TRANS/WP.29/2005/33  
7 April 2005

**DRAFT CORRIGENDUM 2 TO THE 06 SERIES OF AMENDMENTS  
TO REGULATION No. 14**

(Safety-belt anchorages)

Transmitted by the Working Party on Passive Safety (GRSP)

**Figure 11:** ALTERNATIVE METHOD OF LOCATING THE TOP TETHER ANCHORAGE USING THE "ISO/F2" (B) FIXTURE, ISOFIX ZONE - SIDE, TOP AND REAR VIEWS"

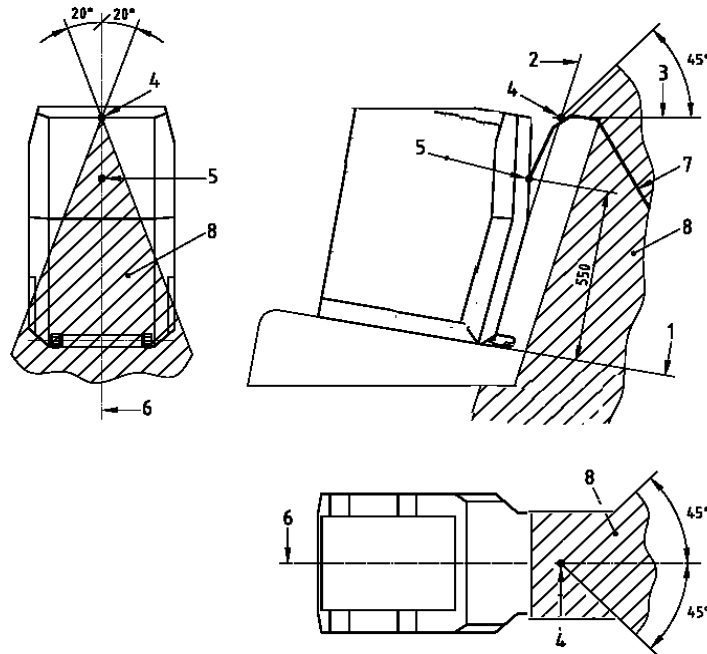
The intersection between the "ISO/F2" (B) fixture rear face and the horizontal line (Annex 9, Figure 11, reference 3) containing the last rigid point of a hardness greater than 50 Shore A at the top of the seat back defines the reference point 4 (Annex 9, Figure 11) on the centreline of the "ISO/F2" (B) fixture. At this reference point, a maximum angle of 45° above the horizontal line defines the upper limit of the top tether anchorage zone.

In the top view, at the reference point 4 (Annex 9, Figure 11), a maximum angle of 90° extending rearward and laterally and in the rear view, a maximum angle of 40° defines 2 volumes which limit the anchorage zone for the ISOFIX top tether.

The origin of the ISOFIX top tether strap (5) is located at the intersection of the "ISO/F2" (B) fixture with a plane 550 mm distant above the "ISO/F2" (B) fixture horizontal face (1) on the "ISO/F2" (B) fixture centreline (6).

Annex 9, Figure 11, amend to read :
